Proposal for a new supplement to the 03 series of amendments to UN Regulation No. 51

The text reproduced below was prepared by the experts from OICA in order to address the original intent of the Task Force on Quiet Road Transport Vehicles (TF QRTV) to the 03 series of amendments to UN Regulation No. 51. This text is based on the adoption of GRBP/2024/22 and will replace GRBP-80-21. The modifications to the current text of the UN Regulation are marked in bold for new or strikethrough for deleted characters.

Graph 1: Noise emission limits for EVs

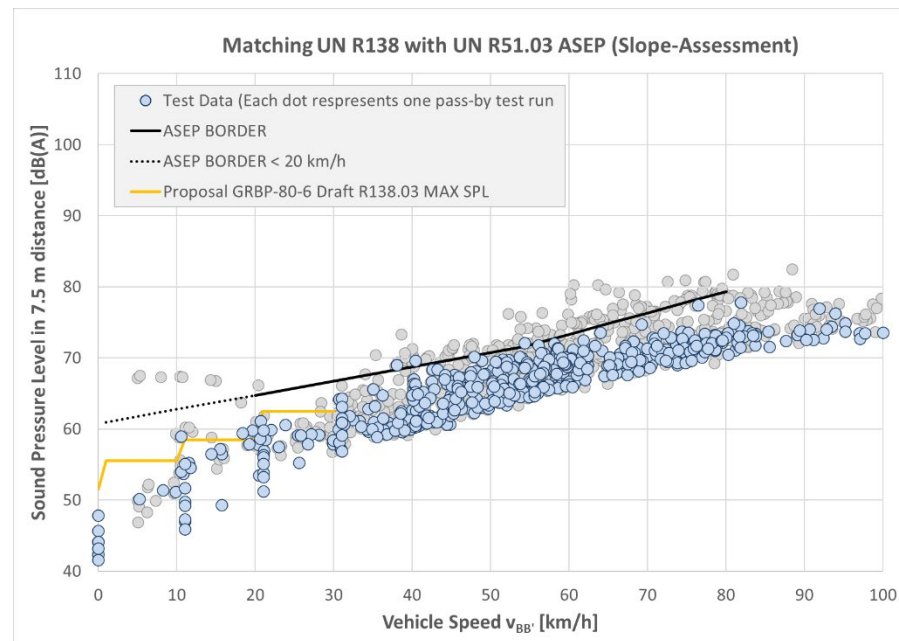
3. Explanation of the graph 1:
 - a) The proposed limit (dotted black line) is related to accelerated conditions of ASEP, which are the worst conditions for urban noise emission.
 - b) The yellow stairs are the limits proposed in GRBP-80-06 by EC for rolling condition (corrected from 2 m of UN-R 138 to 7.5m distance of UN-R 51), which are the best conditions for urban noise emission.

- c) Regarding paragraph 6.2.8. of UN-R 138 any other driving condition, like acceleration, shall not deviate in a significant matter. GRB-68-03 quantifies a significant matter with a value of greater than 6 dB. To compare the EC proposal (yellow steps) with the OICA proposal (dotted black line), a margin of 6 dB has to be added to the yellow steps.

- d) This brings us to the result that there is nearly no difference in low speeds < 10 km/h and for the higher speeds OICA’s ASEP proposal is even more restrictive.

- e) The crossing point at 0 km/h matches the maximum noise limits for stand-still condition in UN Regulation 138/02 (corrected from 2.0 m to 7.5 m due to the different methods in UN-R 138 and UN-R 51). Since we have not a suitable measurement method for EVs in stand still condition, we cannot include it.

- f) The blue and grey dots in the graph 1 represent different driving conditions of different vehicles. The blue dots show pass-by test runs of EVs only equipped with an AVAS, while the grey dots show pass-by-tests of EVs equipped with AVAS and ESES. The limit curve is so designed that vehicles equipped with an AVAS only fulfil the noise emission requirements.
